SERVICE BULLETIN M20-345A Date: December 13, 2022

SUBJECT: 430018-1 Hybrid Elevator Weights on Mooney Aircraft with Smooth Skin Elevators

[ Chapter 27 - FLIGHT CONTROLS]

Figure SBM20-345-1 - M20F/M20G SMOOTH SKIN ELEVATORS AND BALANCE WEIGHT IDENTIFICATION

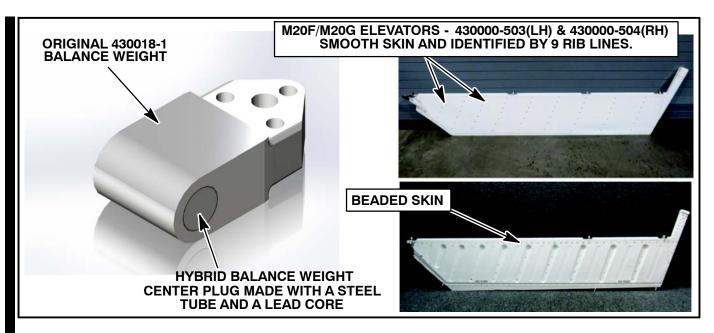
There are specific M20F aircraft with smooth skin elevators 430000-503 (LH), 430000-504 (RH) identified with 9 rib lines, that utilized a hybrid material elevator balance weight. These weights (P/N 430018-1) are identified by the center plug made of chromoly tubing and lead running through the full width of the balance weight. During routine maintenance at an Authorized Mooney Service Center, the elevator balance weights were found to have developed galvanic corrosion, visible signs of the weight is cracked and displaced severely. There have been several instances of this anomaly reported only on M20F aircraft using this hybrid balance weight. Based on original service center discoveries and field reports from the initial released version of this service bulletin, Mooney engineering requests that all 430018-1 hybrid weights be removed and replaced with the 430016-7 lead weights.

- 1.1. Inspect of both elevators for the presence of a hybrid weight, part number 430018-1. The hybrid weight has a steel sleeve at its center plug. Inspect the weight visually and with a neodymium magnet on both sides of the balance weight assembly where the center plug is exposed, to see if the magnet sticks to the steel insert of the hybrid weight as indicated in Figure SBM20-345-1 and SBM20-345-2.

Figure SBM20-345-2 - SIGNS OF GALVANIC CORROSION, CRACKING AND FILLED SIDES OF THE 430018-1 BALANCE WEIGHT

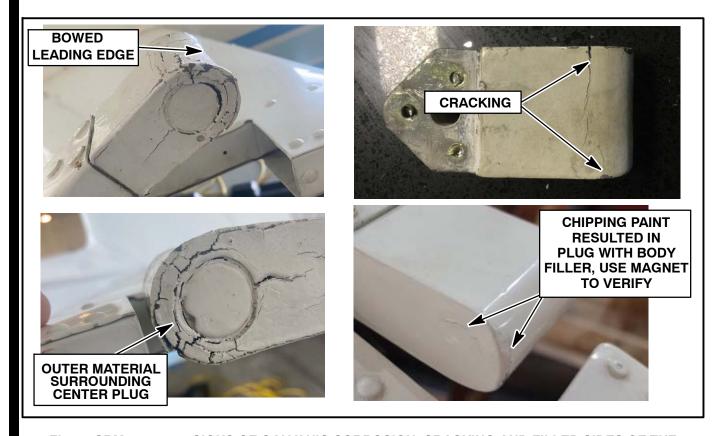
- **1.4.** If the balance weight is determined to be a 430018-1, and cracks are present DO NOT FLY, Continue to **STEP 3**.

Figure SBM20-345-3 - ELEVATOR INSTALLATION

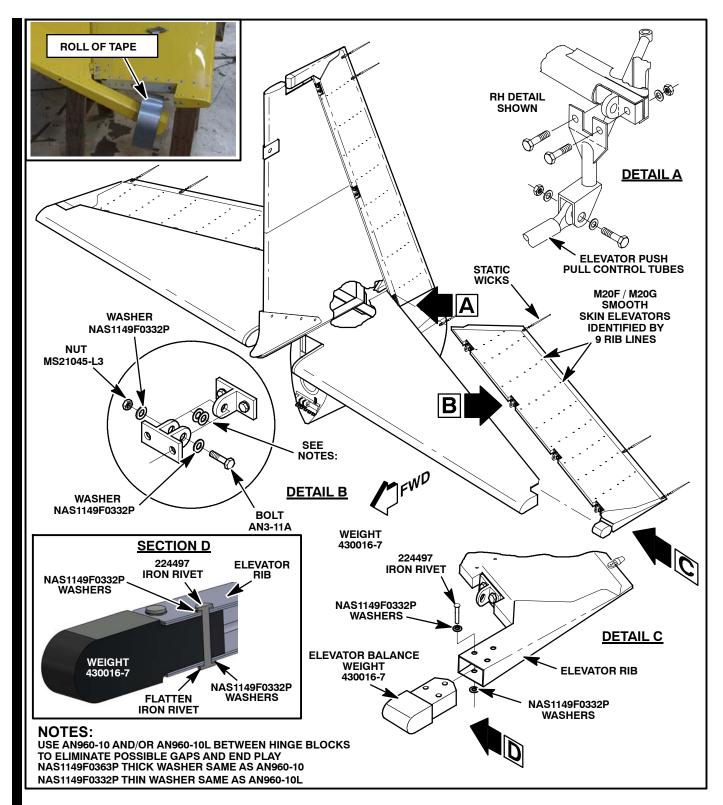
- **2.1.** Disconnect elevator push pull tubes by removing Bolt AN3-10, Washers NAS1149F0332P, Nut MS17825-3 and Cotter Pin MS24665-151, refer to **Figure SBM20-345-3**.
- 2.2. Remove bolts, nuts and washers from the four attaching hinges, note each hinge hardware on zone chart(s) LH Figure SBM20-345-5 and RH Figure SBM20-345-6 as required, refer to Figure SBM20-345-3.
- 2.3. Strip paint from balance weight per applicable Service and Maintenance Manual Section XI.
- 2.4. Inspect balance weight with 10x magnification, if there is no evidence of cracks or chipping of material, continue with Step 2.1.0 BALANCE ELEVATOR With 430018-1 Weights.
- 2.5. If the inspection of Step 2.4 reveals cracks or chipping, continue to Step 3.

- **3.1.** Disconnect elevator push pull tubes by removing Bolt AN3-10, Washers NAS1149F0332P, Nut MS17825-3 and Cotter Pin MS24665-151, refer to **Figure SBM20-345-3**.
- 3.2. Remove bolts, nuts and washers from the four attaching hinges, note each hinge hardware on zone chart(s) LH Figure SBM20-345-5 and RH Figure SBM20-345-6 as required, refer to Figure SBM20-345-3.
- **3.3.** Remove both elevators by pulling it straight aft.

- **3.1.1.** Remove each factory balance weight from elevator, use care while removing Iron rivets, not to damage existing holes in elevator rib, refer to **Figure SBM20-345-3**.
- **3.1.2.** Temporarily install weight 430016-7 to elevator, match drill upper and lower mounting holes to new weight for installing mounting hardware.

- **3.1.3.** When all mounting holes have been match drilled, remove weight and move to drill-press or suitable area to drill each hole as indicated in **Figure SBM20-345-3**.
- **3.1.4.** Temporary install balance weight to elevator.
- **3.1.5.** Balance per <u>STEP 4 Balance Elevator Flight Controls</u>, if balancing needs material to be removed from factory balance weight, continue to <u>STEP 3.1.6</u>, if balance is within tolerance continue to <u>STEP 5</u>. NOTE: Allow for Touch-up Paint weight and mounting hardware.

- **4.2.** When balancing is completed, install balance weight to elevator with Iron rivets p/n 224497, and flat washers NAS1149F0332P as shown in **Figure SBM20-345-3**, refer to the applicable Mooney Service and Maintenance Manual Note: use care while flattening iron rivet. Mooney does not have any other mounting hardware approved at this time.
- **4.3.** Fill out Flight Control Balance Sheets from **Figures SBM20-345-7 and SBM20-345-8** for balance criteria.
- 4.4. When Balance is within Specifications, continue to STEP 5 Install Elevator Flight Controls.

Figure SBM20-345-5 - LH ELEVATOR HINGE ZONE CHART

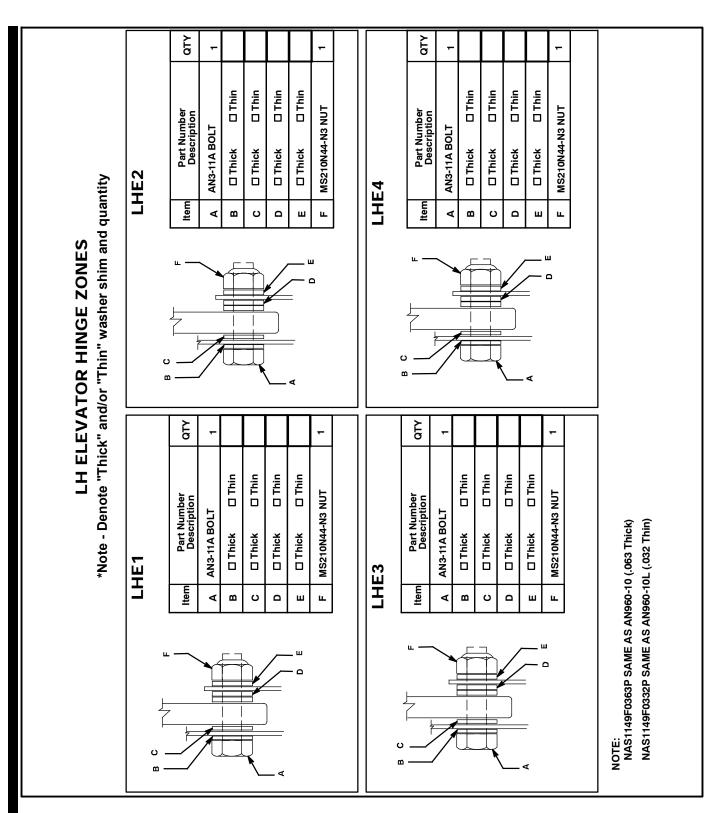
5.1. Install in reverse sequence as removed, refer to Section VI in the applicable Service and Maintenance Manual for hardware torque values. Refer to Elevator Hinge Zone chart(s) LH Figure SBM20-345-5 and RH Figure SBM20-345-6 for stack- up of hardware (use new nuts and cotter pins upon reassembly).
